Access Compliance Report

Public Rights-of-Way

Intersection ID: 10036062	Main Street: RIVERGATE_PY	Cross Street: N/A	Location: E
ADA ID: 91FCCED0132C	Ramp Type: PerpDiag	Initial Pass/Fail: Pass	Overall Compliance: No
		Severity Score: 0.25

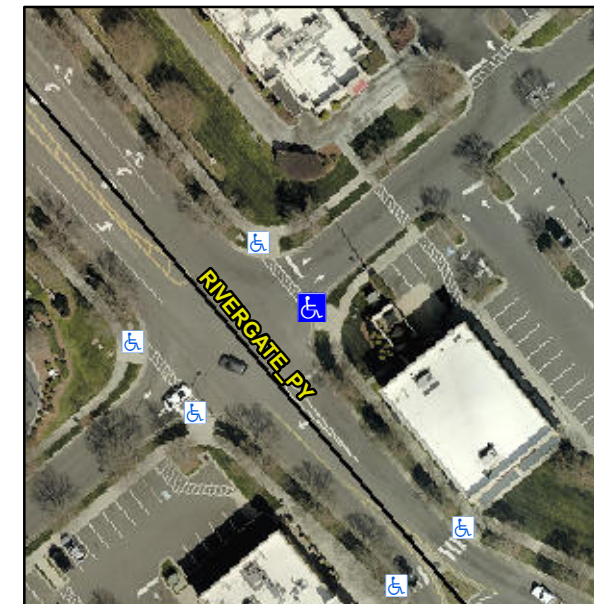
Not Found, R304.5.3, R304.2.2-Perp, R304.3.2-Para

Compliance	Description	Data	Compliance	Description	Data
N/A	Ramp Length (in)	97.0	Yes	Ramp Slope (%)	7.5
Yes	Ramp Width (in)	48.0	No	Ramp XSlope (%)	2.3
N/A	Flare Type LT	Sloped	N/A	Flare Type RT	N/A
N/A	Flare Slope LT (%)	5.0	N/A	Flare Slope RT (%)	7.6
N/A	Flare Traversable LT?	No	N/A	Flare Traversable RT?	No
Yes	Landing Length (in)	71.0	Yes	DWS Provided?	Yes
Yes	Landing Width (in)	48.8	Yes	DWS Contrast?	Yes
No	Landing Slope (%)	2.9	Yes	DWS Length (in)	24.5
Yes	Landing X Slope (%)	2.0	Yes	DWS Full Width?	Yes
N/A	Landing Curb? (Y/N)	No	Yes	DWS Offset (in)	1.0
N/A	Shared Landing?	No			
Yes	Gutter Ponding?	No	Yes	Gutter Slope (%)	4.4
Yes	Gutter Lip Ht (in)	0.0	No	Gutter X Slope (%)	2.1
N/A	Painted X Walk1?	Yes	N/A	Painted X Walk2?	No
	X Walk 1 Direction	To N		X Walk 2 Direction	To W
N/A	X Walk 1 Width (in)	52.0	N/A	X Walk 2 Width (in)	N/A
	X Walk 1 Slope (%)	1.3		X Walk 2 Slope (%)	1.4
	X Walk 1 X Slope (%)	2.2		X Walk 2 X Slope (%)	1.4

Remove & Replace Curb Ramp With Two New Directional Ramps or Equivalent. Remove & Replace Gutter.
